The extensions to the Davyhulme Sewage Works (1957-67)

G. L. SYMES

DISCUSSION

Fig. 7

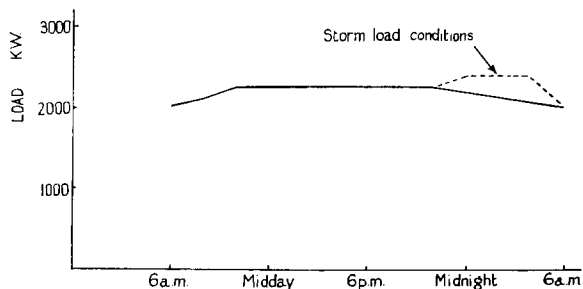
102. The normal load on the generating plant under present operating conditions is a continuous one ranging from 2000 to 2500 kW over twenty-four hours as shown in Fig. 7.

Fig. 8

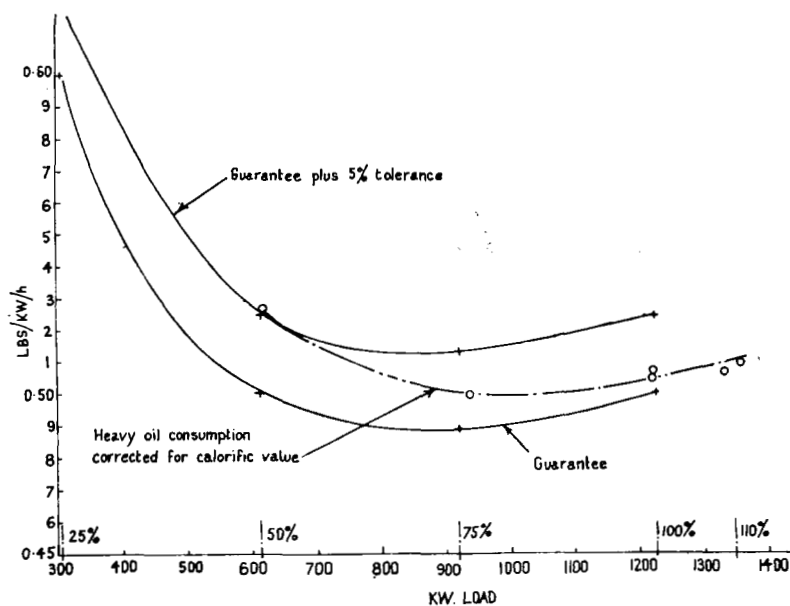
107. Figure 8 shows the performance curve, from 25% to 110% load, of an engine running on heavy oil alone.

108. At 100% load the consumption of 0.505 lb/kWh (shown) coupled with calorific value of 17 550 BTU/lb produces the heat rate figure of 8860 BTU/kWh previously quoted.

Fig. 9

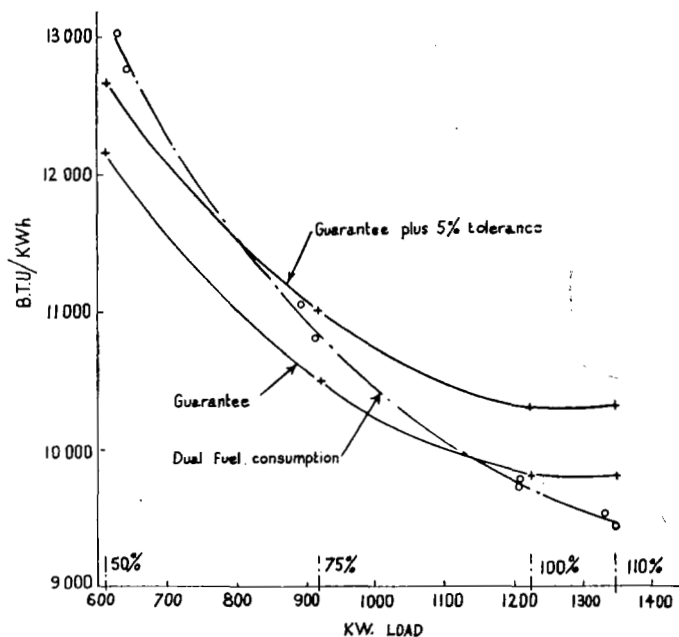
109. Figure 9 shows the consumption from 50% to 110% load of the same engine running on heavy oil and gas.

110. At 100% load the consumption of 9749 BTU/kWh (shown) is coupled with a calorific value of 17 550 BTU/lb for oil and of 595 BTU/cu. ft at NTP for gas.

111. It is clear from these results that the use of gas reduces the full load efficiency by approximately 10%.
